# Service Bulletin

Bulletin No.: PI0686B

**Subject:** Front Seat Lateral Movement, Clunk, Squeak, Click Noise or Shift While Cornering

**Models:** 2012-2014 Buick Verano  
2011-2014 Chevrolet Cruze  
2014 Chevrolet SS  
Equipped with RPO A53, ADS, AH4 6-Way Power or 6-Way Manual Driver or Passenger Seat

2773104

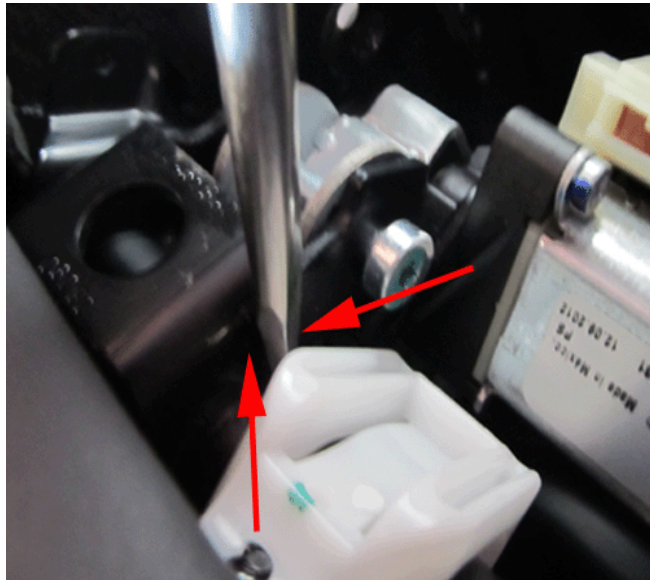
1. Raise the front of the seat bottom to the highest position and move the seat assembly to the rearmost position.

**Note:** Cruze shown, Verano and SS similar.

3932441

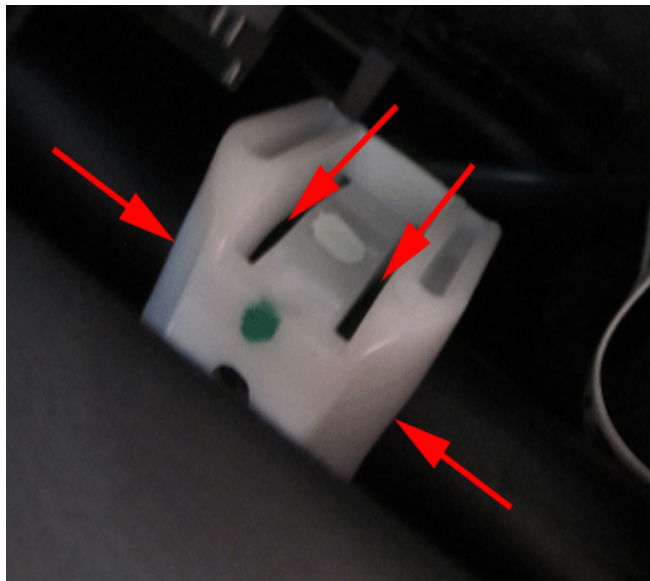
3. Install the clip as shown. Ensure the clip is fully seated around the crossbar and on the guide block.

**Note:** You may need to move the crossbar using a flat head screwdriver to properly align the clip.

2773113

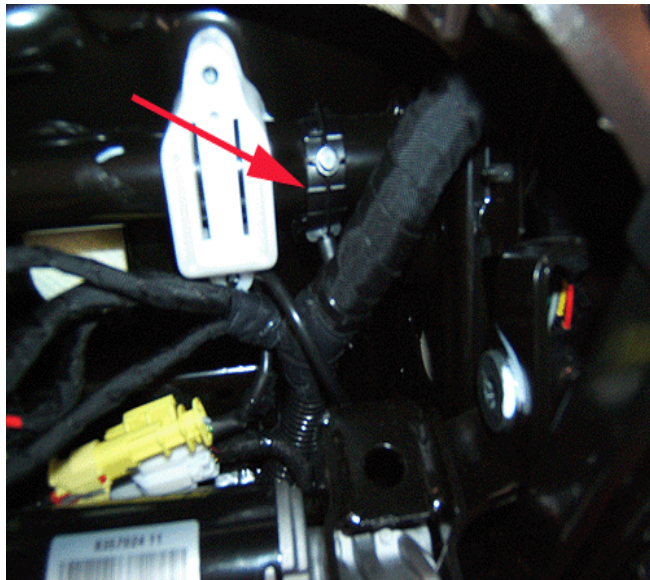
**Note:** Spray Super Lube, P/N 12346241, or equivalent to the areas on the white clip, as shown in the illustration above, to ensure that the noise is eliminated.
